Form 3160-5
(February 2005)UNITED STATES
DEPARTMENT OF THE INTERIOR
BUREAU OF LAND MANAGEMENTFarmington Field Office
Bureau of Land ManagementFORM APPROVED
OMB No. 1004-0137
Expires: March 31, 2007

SUNDRY NOTICES AND REPORTS ON WELLS

W Lybrook Unit 743H

WPX inadvertently moved the drilling direction of the W Lybrook Unit #743H lateral from the original permitted plan previously approved in the APD and failed to submit an NOI stating the change of plans.

WELL LOCATION AND ACREAGE DEDICATION PLAT

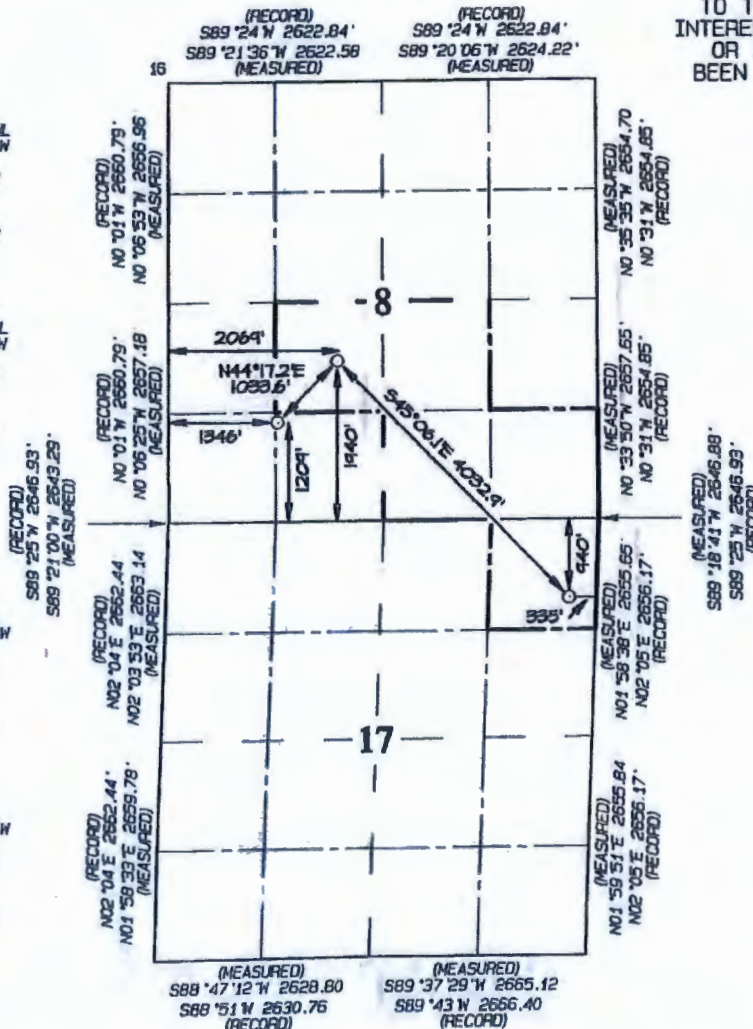
Attached are the accurate plans in accordance with what was drilled.

As Drilled
